# Addendum 01

**DATE:** February 19, 2024

**PROJECT:** EACS New Haven Primary, Leo Elementary and Cedarville Lighting Replacement  
1445 Berwick Lane, New Haven, Indiana 46774 (New Haven)/  
14811 Wayne Street, Leo, Indiana 46765 (Leo)/  
12225 Hardisty Rd, Fort Wayne, Indiana 46845 (Cedarville)

**PROJECT #:** 23085.00

E1.1

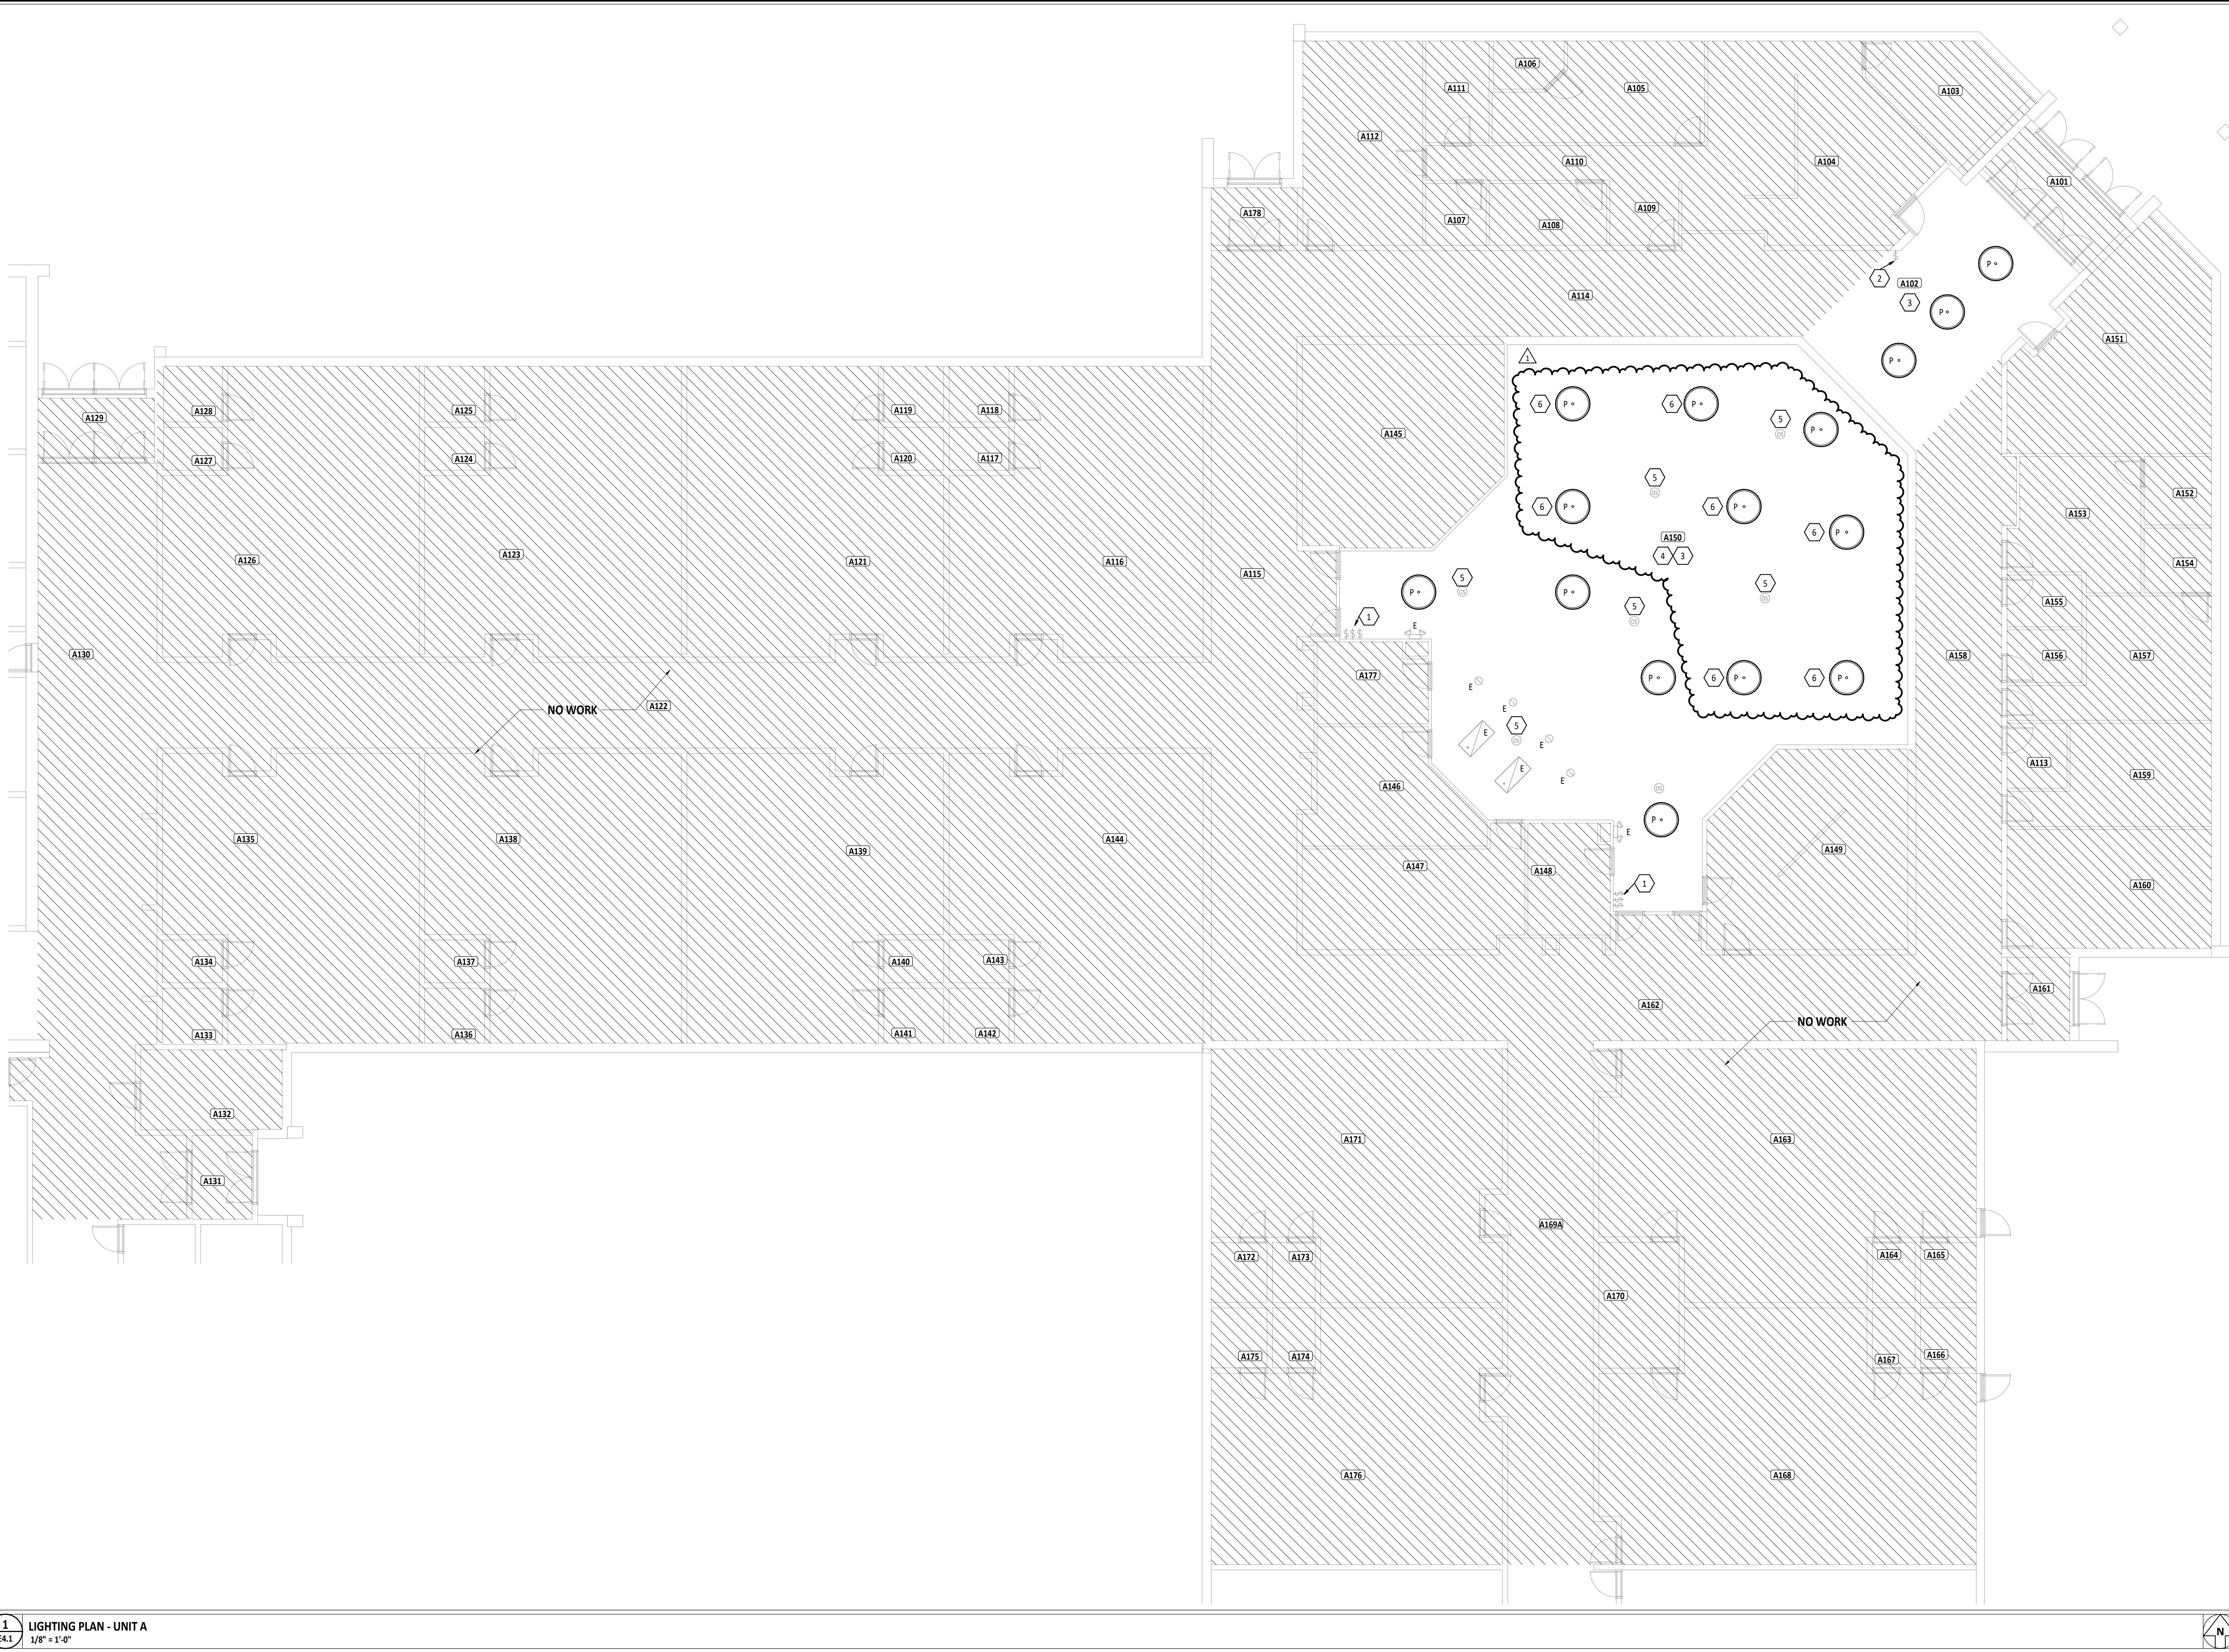
1. Drawing Sheet E1.1 General Notes, Abbreviations, Legends, & Schedules: Luminaire Schedule: Remove equivalent manufacturers and modify parameters for luminaire type 'P' to increase aircraft cable length and to coordinate exact mounting heights with owner.
2. Drawing Sheet E4.1 Cedarville – First Floor Electrical Plan - Unit A: Detail 1 Lighting Plan – Unit A: Clarify mounting of pendant fixtures in media center that are installed in sloped ceiling.
